Proposal for amendment of document ECE/TRANS/WP.29/GRSP/2014/10

Draft new Regulation on uniform provisions concerning the approval of passenger cars with regard to the protection of the occupants in the event of a frontal collision with focus on the restraint system

Submitted by the expert from France as Chair of the Informal Working Group on Frontal Impact *

Fig.X The initial knee distance of Hybrid III 5th percentile female

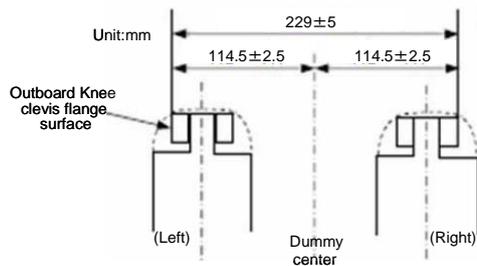
The upper legs of the passenger test dummy shall rest against the seat cushion to the extent permitted by placement of the feet. The initial distance between the outboard knee clevis flange surfaces shall be ~~{270 mm ± 10 mm}~~ **[229 mm ± 5 mm]** as shown in Fig.X. To the extent practicable, both legs of the passenger dummy shall be in vertical longitudinal planes. Final adjustment to accommodate placement of feet in accordance with paragraph 3.6. for various passenger compartment configurations is permitted.

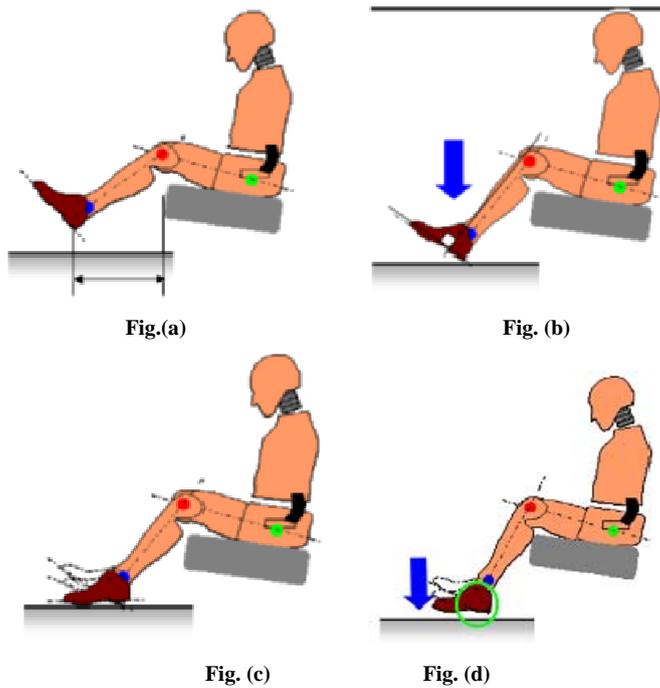
The legs shall be positioned as distant as possible from the front end of the rear seat cushion while the thighs are kept in contact with the seat cushion as shown in Fig.(a). As shown in Fig.(b), each leg shall be lowered until the foot comes in contact with the floor while the foot and tibia are kept in a right angle to one another and the thigh inclination angle kept constant. When each heel is in contact with the floor, the foot shall be rotated so that the toe comes as much in contact as possible with the floor as shown in Fig.(c).

If it is not possible to have each foot in contact with the floor, the foot shall be lowered until the calf comes in contact with the front end of the seat cushion or the back of the foot comes in contact with the vehicle interior. The foot shall be kept as parallel as possible to the floor as shown in Fig.(d).

Fig.

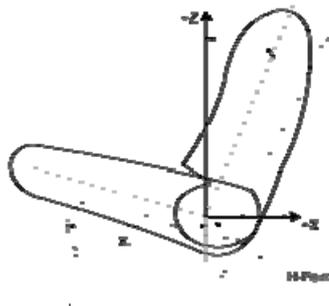
4.16. The longitudinal and vertical dimension of "H" point are described as (X_{50thM} , Z_{50thM}) and the longitudinal and vertical dimension of "H 5th" point are described as (X_{5thF} , Z_{5thF}). XSCL is defined as the horizontal distance between the "H" point and the most forward point on the seat cushion (see Fig). Use the following formula to calculate the "H 5th" point. Note that X_{5thF} should always be more forward than the X_{50thM} .

$$X_{5thF} = X_{50thM} + (93\text{mm} - 0.323 \times \text{XSCL})$$

$$Z_{5thF} = Z_{50thM}$$
